PCN#20140903000

**Qualification of TIPI as new Assembly Site for Select Devices
in the PBGA/nFBGA Package
Change Notification / Sample Request**

Date: 9/11/2014
To: MOUSER PCN

- Group 1 Devices as follows:

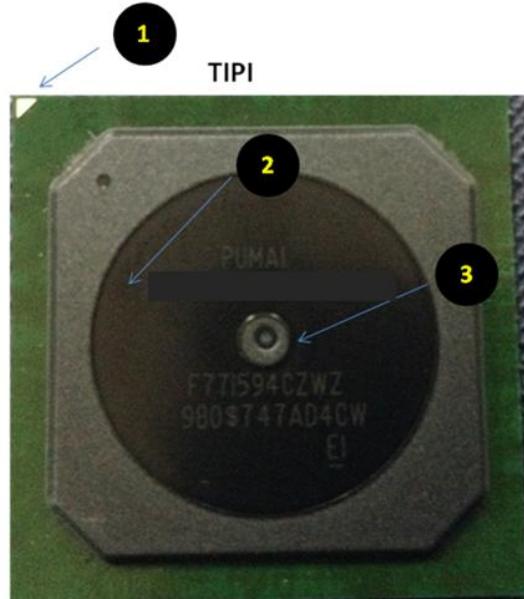
15x15 TLK3132ZEN actual TIPI unit
• Heat slug color is black.

- Group 2 Devices as follows:

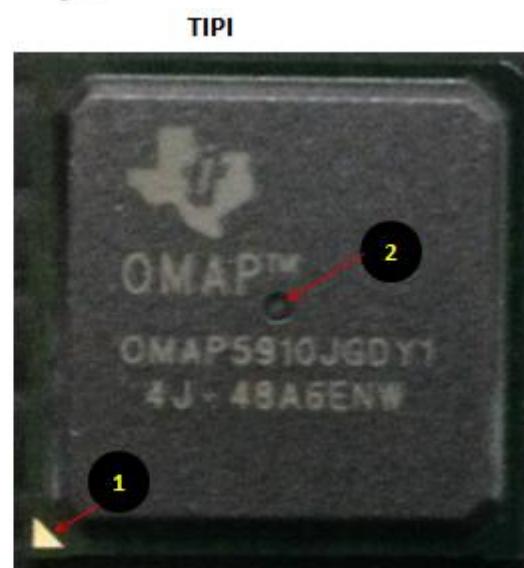
- Pin 1 indicator is a small triangle.
- Heat slug is color black.
- Heat slug has hole in center for top gate.

- Pin 1 indicator is a small triangle.
- Has indentation on center for top gate.
